Riverlea

HCL Figure 11 – Salinity at 100 years

Figure A5. Interpolated regional groundwater level contours

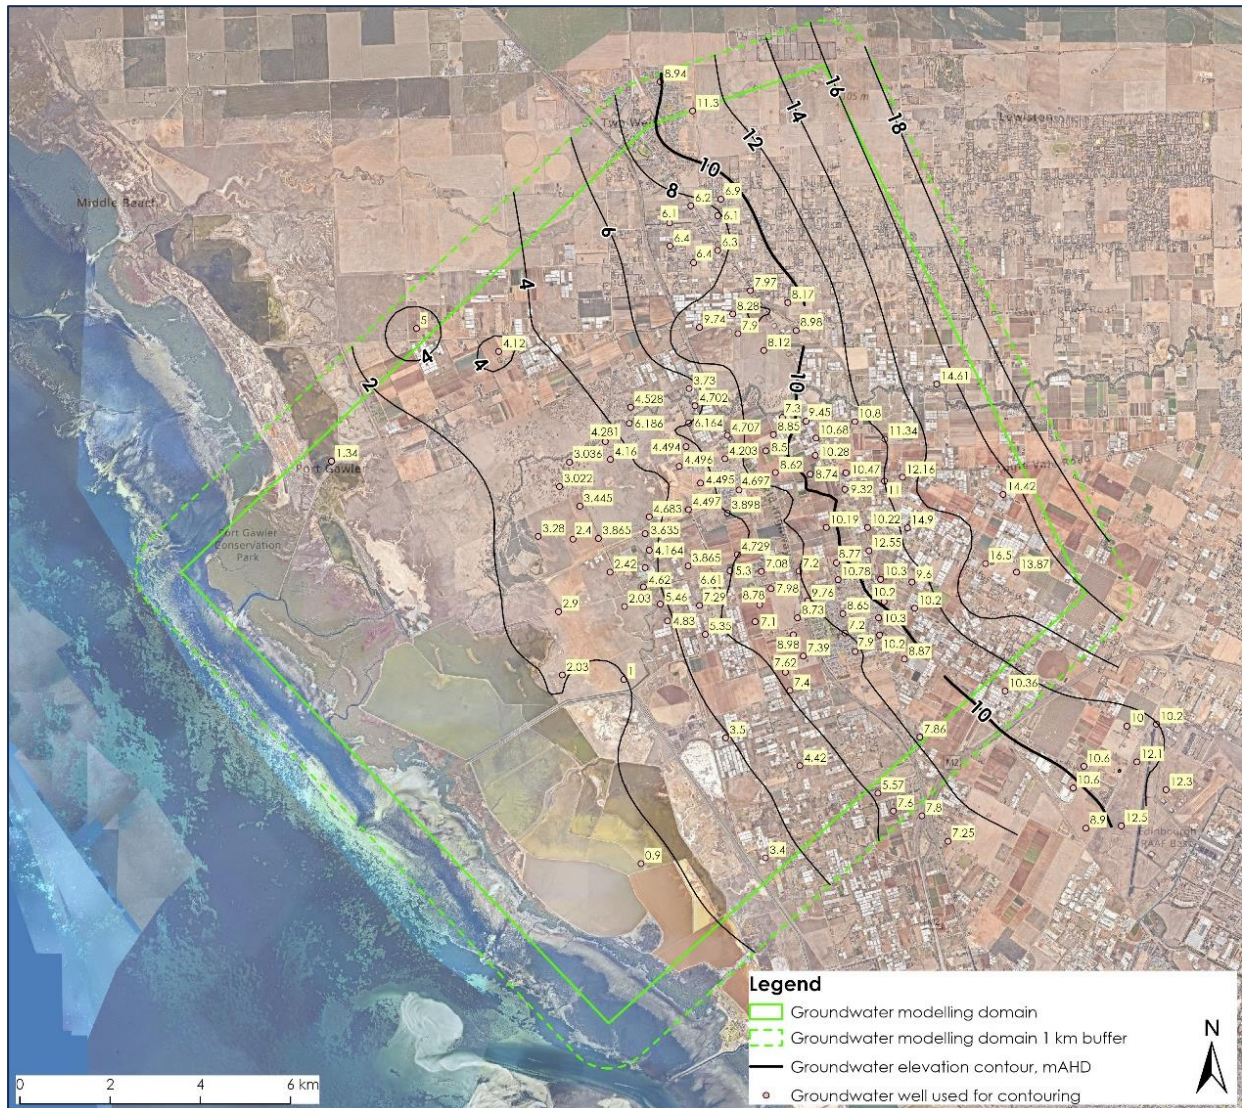
11. Figure 5: these figures are unacceptable. Potentiometric surface maps must be developed for a specific period of time for the same aquifer. These surfaces cover decades and no indication is given as to which aquifer has been measured.

The contours in Figure 5 are based on data for wells less than 15 m deep, representing the Q1 aquifer. This is clearer when the HCL report is read as intended, in the context provide by the LBW report.

There is no short period of time for which groundwater level information is available that has good lateral coverage across the full model domain. The approach adopted for Figure 5 made use of as much of the available water level information as possible and leads to groundwater level contours that are generally consistent with those interpolated based on smaller datasets for specific short periods of time.

A clearer version of the left-hand part of Figure 5 is provided as Figure A5 below. The contours are based on the most recent datapoint for every well for which groundwater level information is available since the year 2000.

Figure A6. Hydrographs for adjacent wells 6628-2515 and 6628-2516

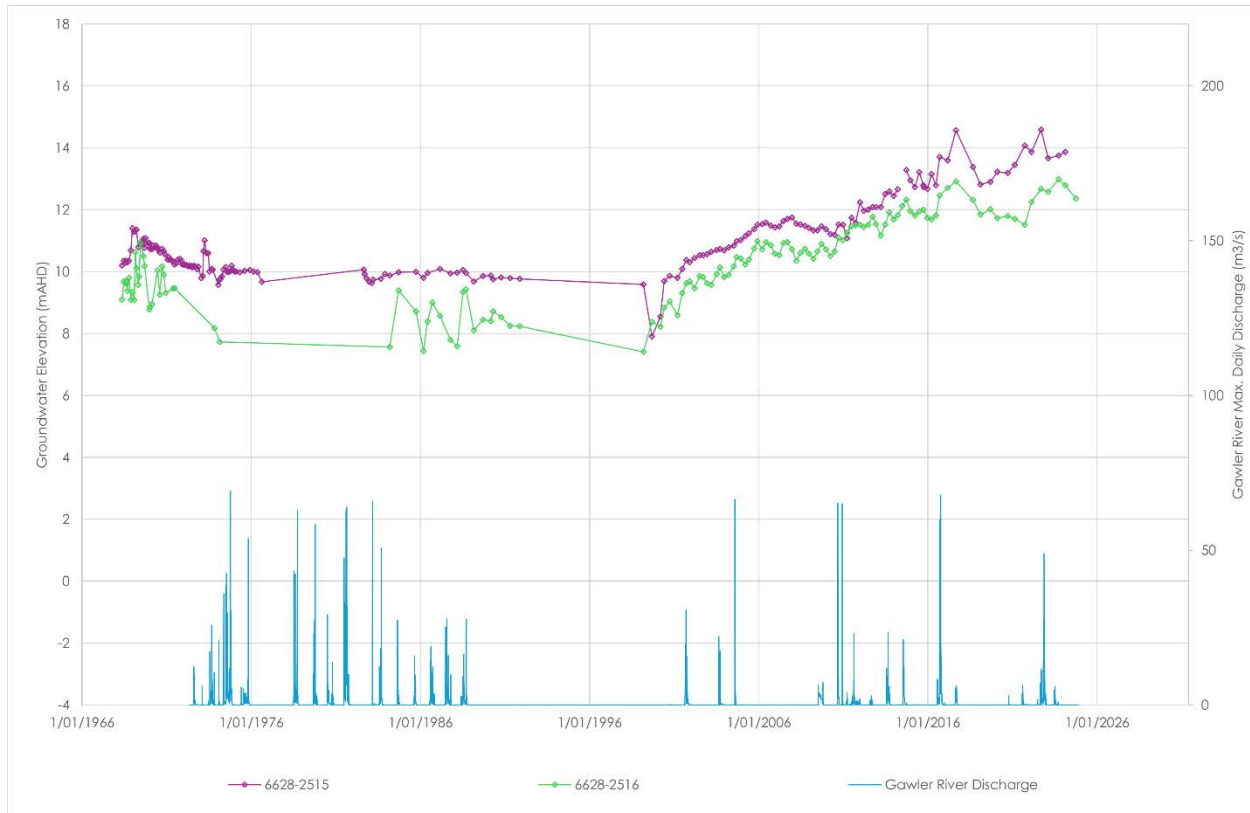
13. Figure 7: Please provide a caption. Do the green lines indicate the model boundaries? If so, bore 6628-2515 has risen 4.2m since 2000. This will affect whatever boundary condition is chosen for the model.

Well 6628-2515 shows an increasing water level trend since approximately the year 2000, during which time it has risen from around 10 to 14 mAHd (average increase c. 0.17 m per year). Because no other wells show the same degree of increase, it is unclear whether these changes are very local to the well or whether they are representative of a wider area. The situation is complex because further investigation has showed that a nearby deeper well (6628-2616) that is reported to be screened in the Q3 aquifer shows a very similar trend – refer Figure A6. Both wells are within an area used for growing crops under cover and outdoors, so there is the potential for locally elevated groundwater levels due to either to leaking water pipes or excessive irrigation, as well as the potential for local vertical hydraulic connection between the different aquifer units.

LBWco recently inspected 6628-2515 and identified the well to be capped at ground level in a low-lying roadside area subject to inundation. The increasing water level trend may be influenced by local drainage of stormwater down this well, and other factors.

Figure A7. Interpolated groundwater level at specific times

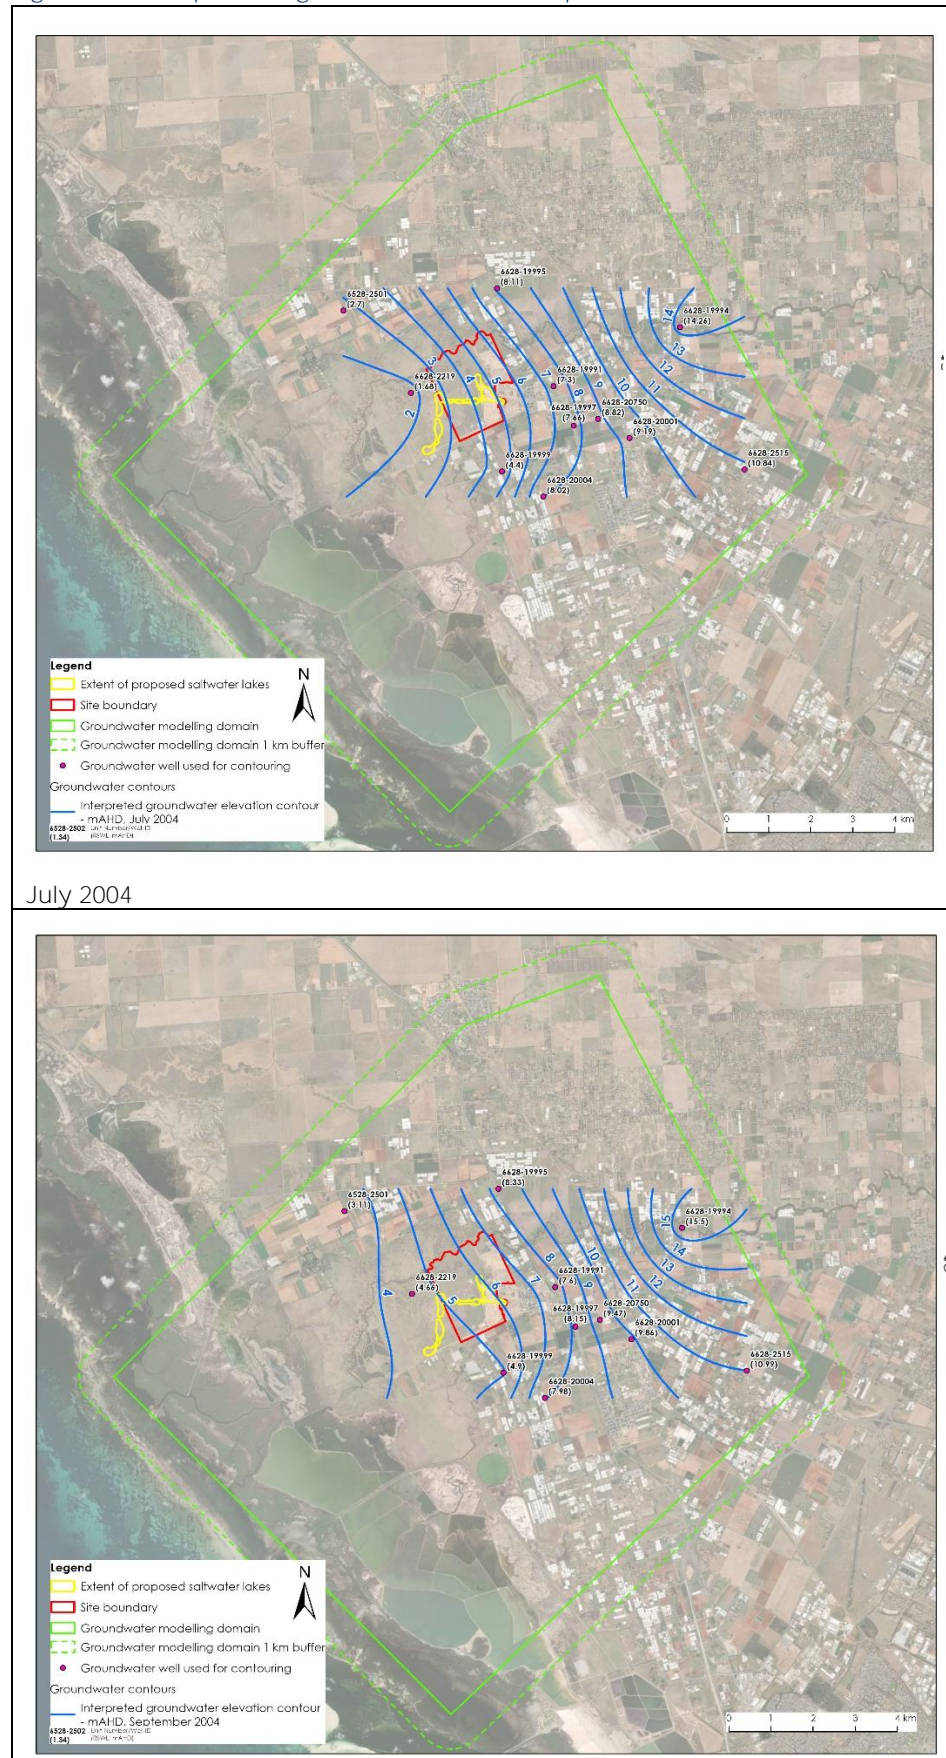
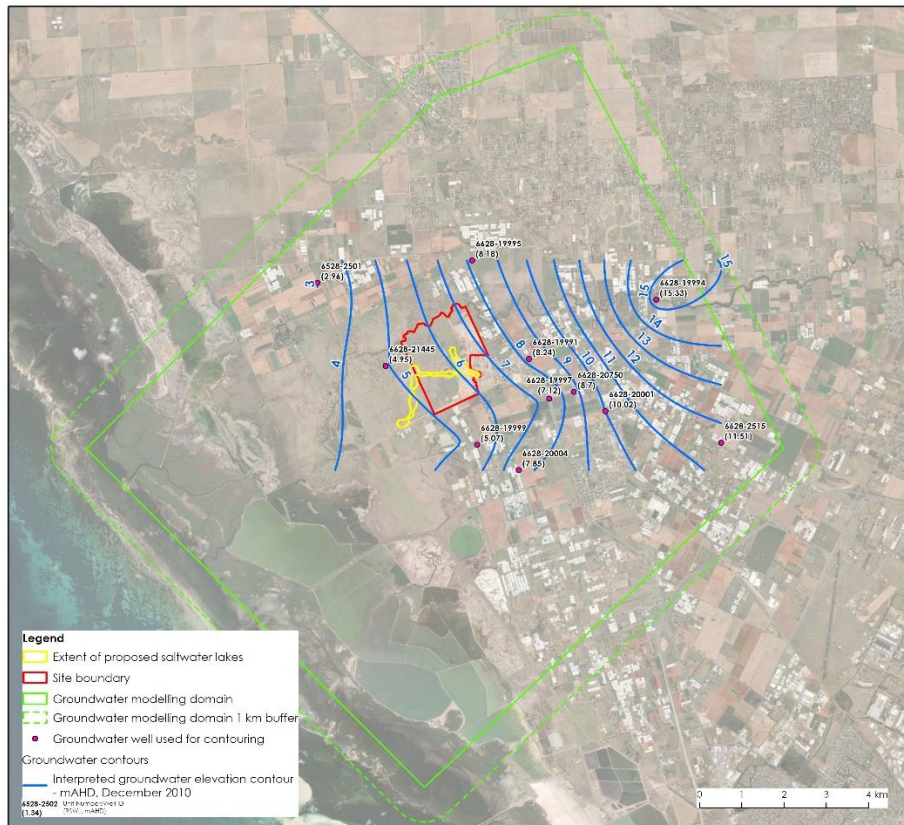
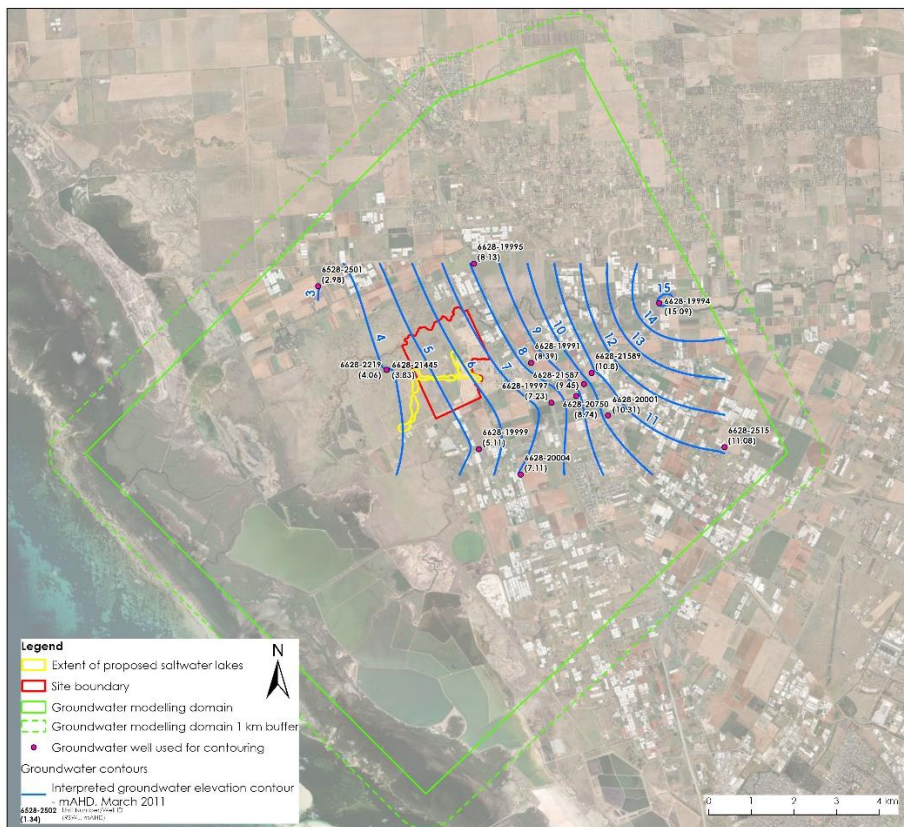
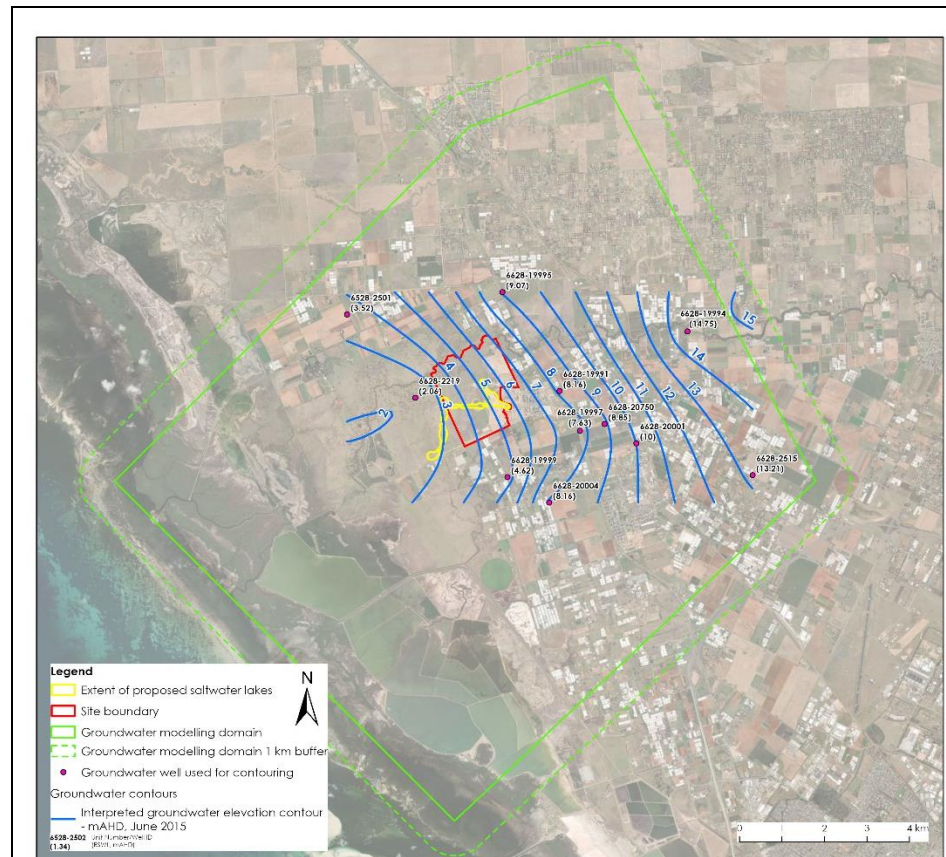
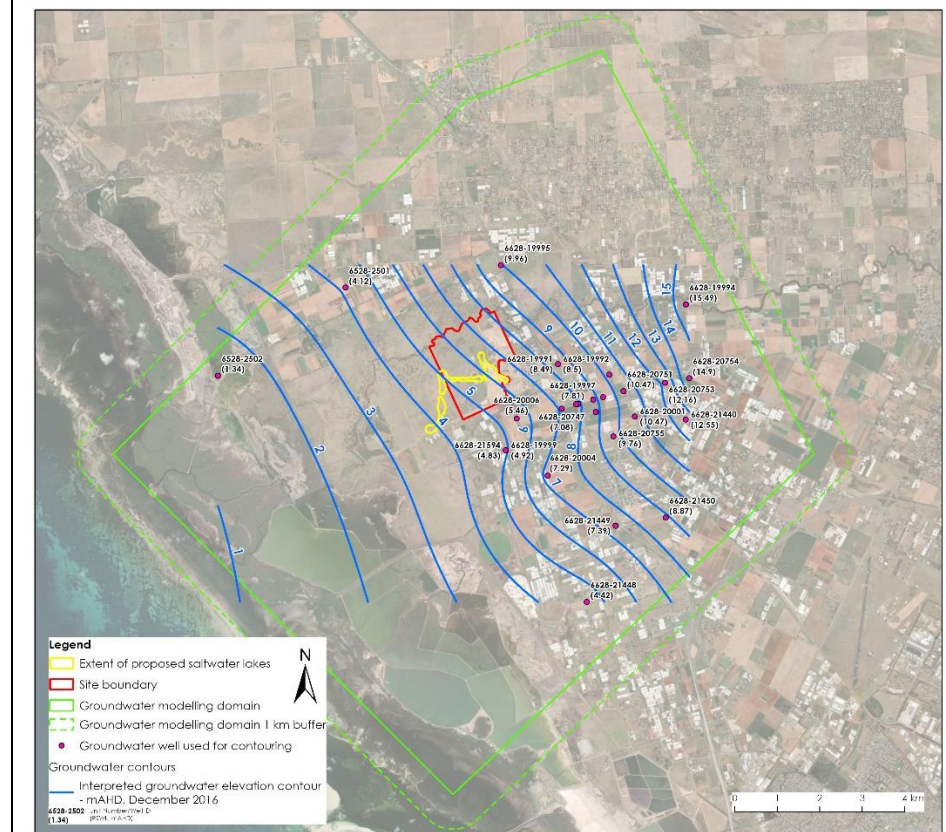
12. Figure 6: DEW are disappointed to see only 1 hydrograph that covers the period 1968 to 2000 and only 4 others since 2000. Furthermore, these hydrographs show quite significant increases since 2000, suggesting that the potentiometric surface in Figure 5 is unsupported.

As noted above, there is no short period of time for which groundwater level information is available that has good lateral coverage across the full model domain. Figure A7 below provides interpolated groundwater level contours for the months for which the largest amounts of data are available. The best coverage is for December 2016 but none of the contour plots cover the full model domain. For that reason, taking into account the general stability of water levels over time, the decision was made to make best use of all the wells for which at least some data was available since the year 2000, by using the most recent water level information to construct the contours shown in Figure 5 of the HCL report and Figure A5 above. The interpolated contours for December 2016 show the same general picture as the contours in Figure A5. None of the contour plots include information near the northeast or southwest corners of the model domain.

LBW has undertaken additional collation of historic groundwater level data since the HCL report was prepared. Some additional hydrographs and sets of groundwater level contours have been developed as presented in Figures A1 and A7 above and discussed in the response to comment 11. The overall picture is similar to what was presented previously and indicates that the potentiometric surface in Figure 5 of the HCL report remains a reasonable approximation of the average groundwater level in the domain area.

Figure A9. Model cross-section

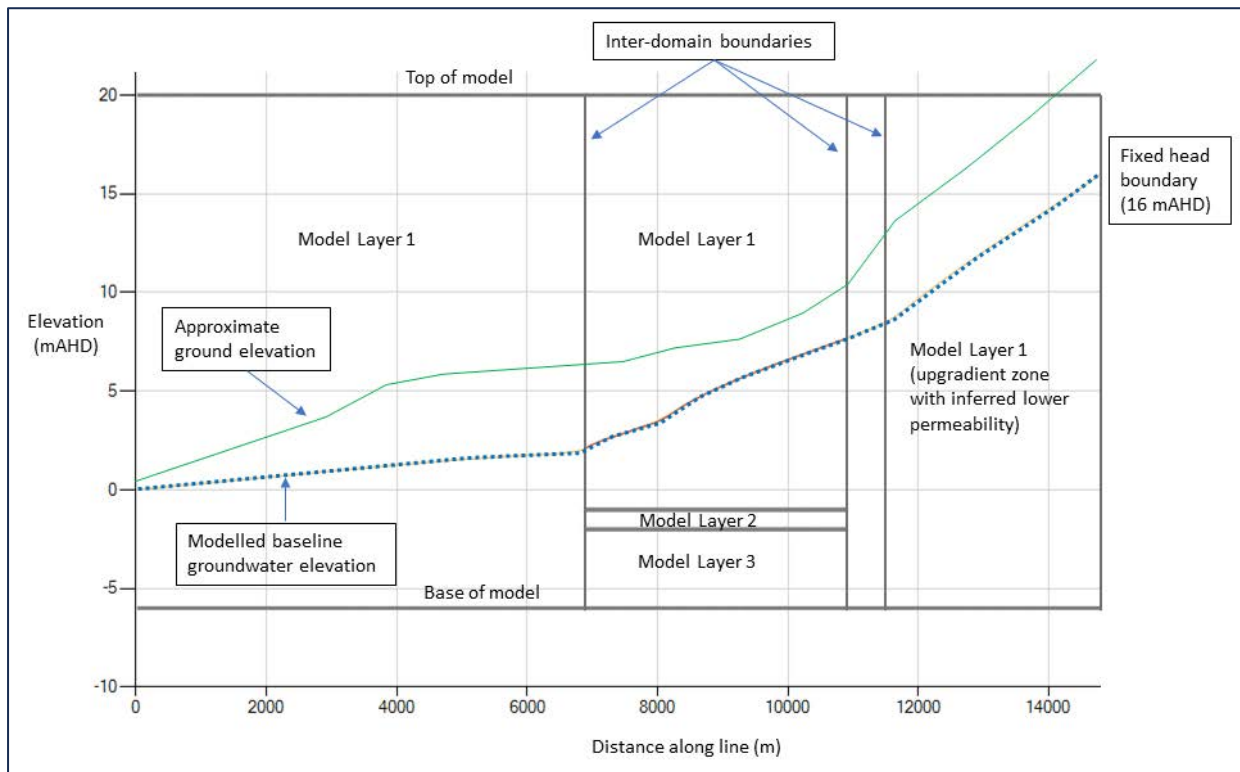
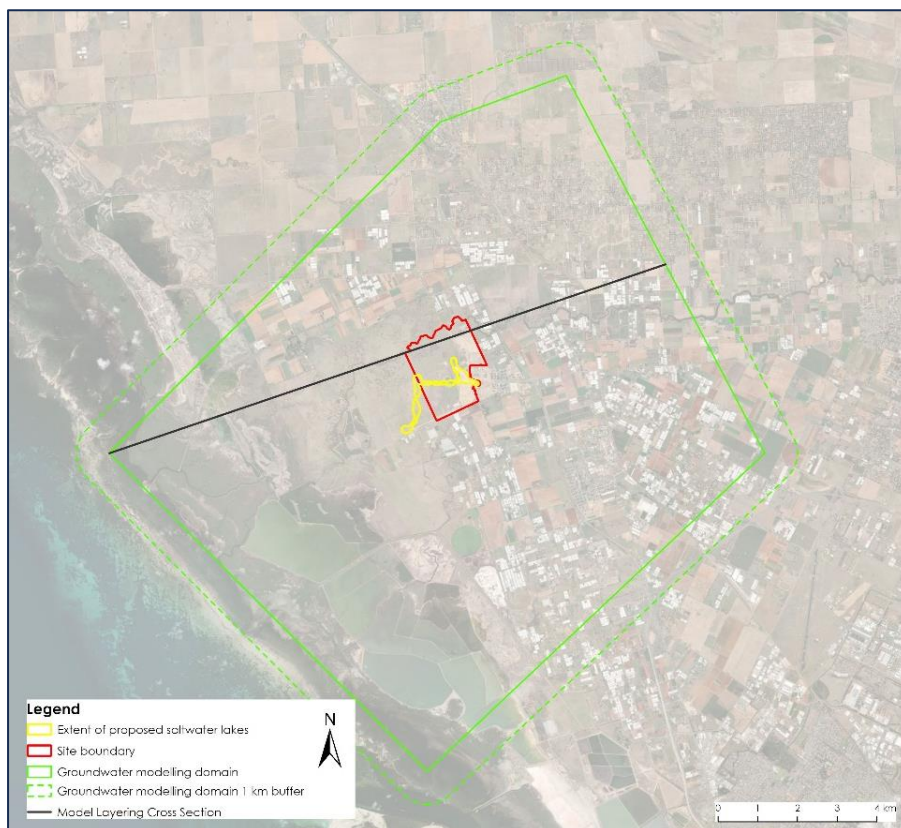
24. Figure 9 and text: There really needs to be a stratigraphic diagram that show this 3-layered subset of the larger 1-layer model.

Figure A9 provides a cross-section to illustrate the vertical layering that is incorporated in the groundwater model. The section line is shown on Figure A10.

Figure A11. Modelled and observed groundwater level contours (mAHD)

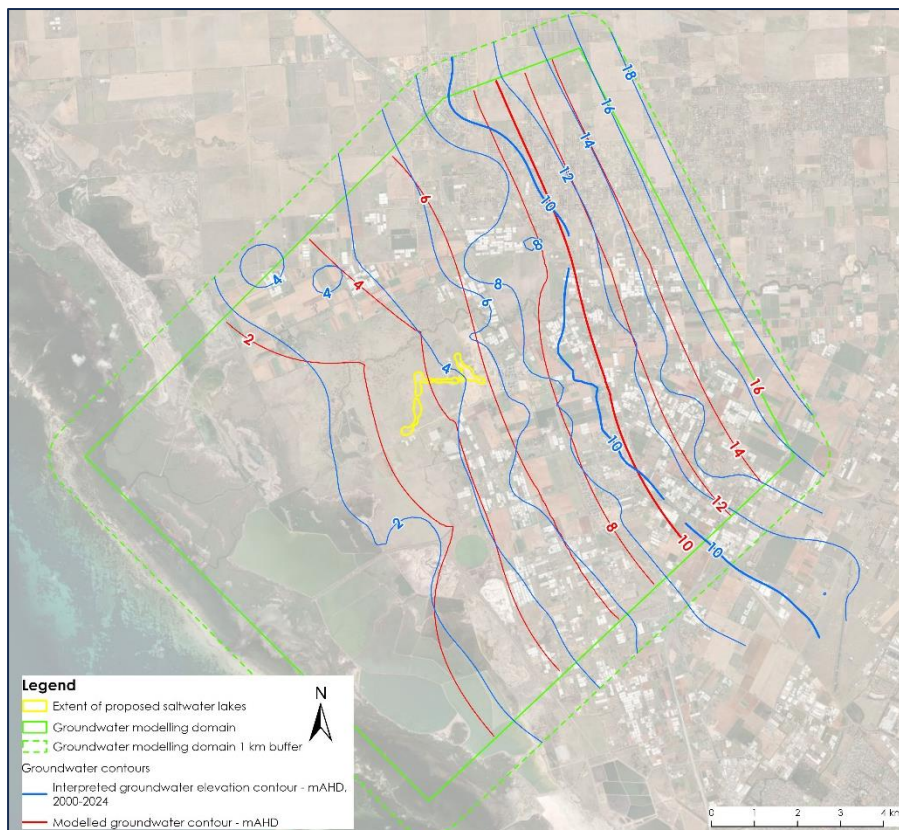
20. Section 3.4: DEW assume the NE boundary condition of 16 mAHD fixed head is based on Figure 5, which is wrong. Figure 5 needs to be corrected, and a supportable boundary condition used. The no-flow conditions are probably supportable but would need to be reassessed once Figure 5 is corrected.

See earlier responses (especially 11) in relation to DEW comments on Figure 5. A clearer version of Figure 12 is provided in Figure A10 below.
